TUESDAY, SEPTEMBER 8, 2020

Work Session ~ Grabhorn Park Concept, 6:00 p.m.

PROJECT NAME: Grabhorn Park	3J PROJECT NUMBER: 20602	
TO: Chris Negelsbach, PE City of Scappoose - City Engineer	FROM: Jim Schmitt, PE Civil Engineer	DATE: August 19, 2020

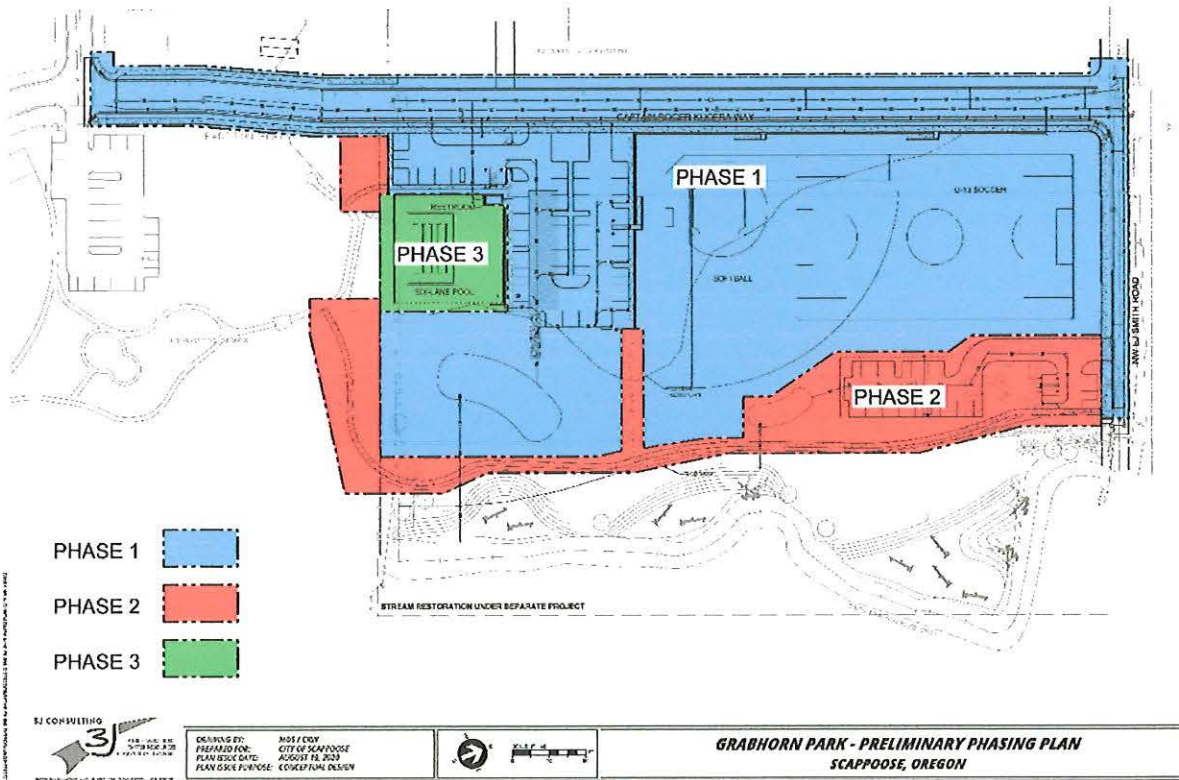
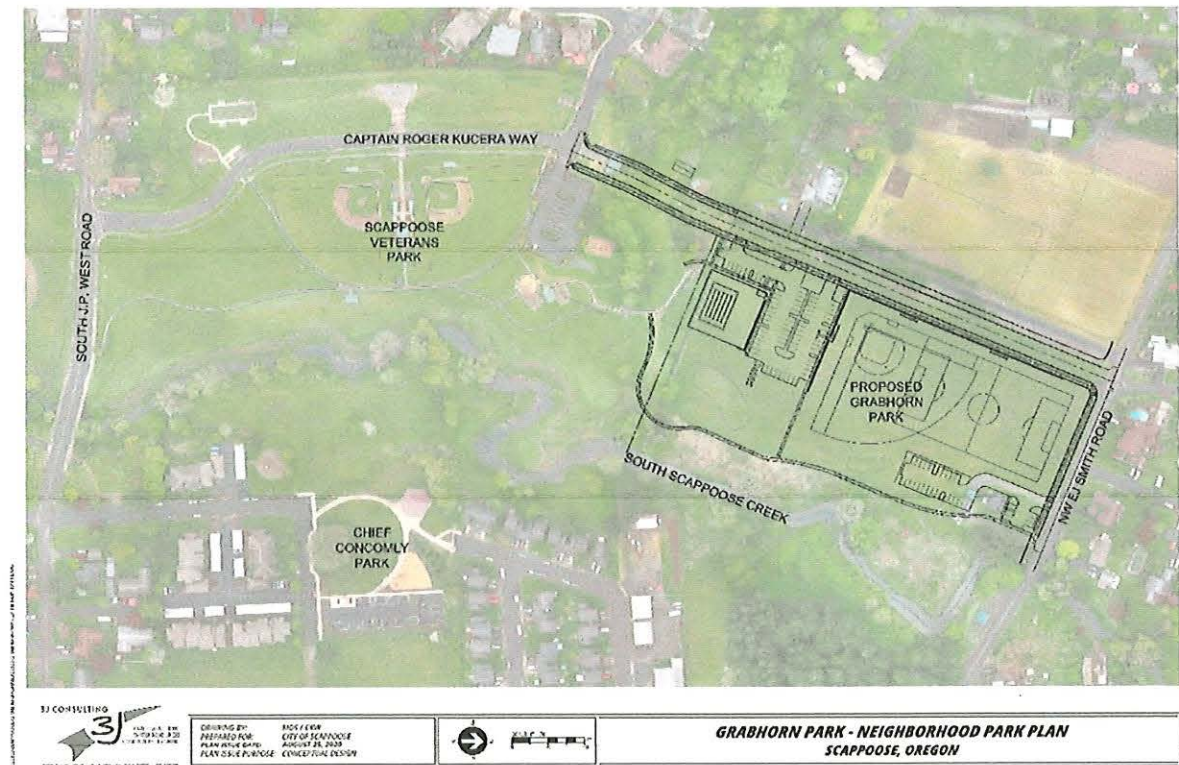
There was a discussion on keeping the dog park.

Mayor Burge asked about widening the road through the park.

Councilor Greisen stated to Mayor Burge making the comment at the beginning of the meeting, is there something we can do today as a staff and as a Council we agree that the dog park will be moved in Phase 1 and it is noted here, we don't know where it is going to go, but it is an important priority to make that happen in the initial stage.

Councilor McHugh stated he thinks there should be an asterisk on the conceptual plan that states "future location of dog park to be determined".

- a. The 500 year floodplain needs to be delineated in this planning, along with the 100 flood (which will vary over time) from north city limits to south city limits...the big picture and what we are willing to achieve over the next 100 years....then how this site and parkland to the south fit in.

1. Cpt. Roger Kucera Road – given the creek runs through the park, expanding the road over a protected creek is concerning and highly disruptive to the natural habitat. Was there an environmental assessment completed prior to the draft design? Does this plan take into account the uptick in traffic and the effects on the creek? Placing a road through this area appears to be financially expensive and intrusive to the natural habitat. Suggestion, create a separate entrance and exit from NW EJ Smith Road that does not connect with Cpt Roger Kucera Road. By doing so establishes Grabhorn as a ‘separate’ park yet trail connected and provides a barrier to drivers cutting through JP West to EJ Smith and vice versus, while reducing the \$3.5M price tag.

2. The Dog Park – this plan clears the dog park with no indication of relocating the dog park. Why? This is short sighted given the dog park is a heavily utilized amenity in the community, and personally a heavily weighted selling point for the purchase of our home nearby. Is there a future plan to relocate the dog park? By not expanding Cpt. Roger Kucera Rd through, the dog park would be able to stay.

5. Street Parking – from the plans it appears the parking is on the sides of the road. Is it the same parking style as on Cpt. Roger Kucera Road? Does this plan allow for two cars to pass by with parked cars on either side, or does one car need to wait in order for another pass and vice versa? The current street parking on Cpt. Roger Kucera Rd is awkward.

The City does not regulate the 500-year floodplain and it is not required to be delineated on development plans, which is why it is not showing on the concept plan that Council is reviewing tonight. In most cases, the 500-year floodplain boundary is fairly close to the 100-year boundary, and in the case of this parcel, the 500-year boundary is ~50-feet west of the 100-year boundary.

The City does not propose to do any work within the floodway and Chapter 17.84 stipulates that there be no net fill within the 100-year floodplain boundary. This means that any cuts/fills within the 100-year floodplain boundary must be balanced so that no additional fill is placed within the 100-year floodplain that could contribute to an increase in base flood elevations. The concept plan that Council is reviewing tonight achieves this requirement and was the driving force of what was possible on site.
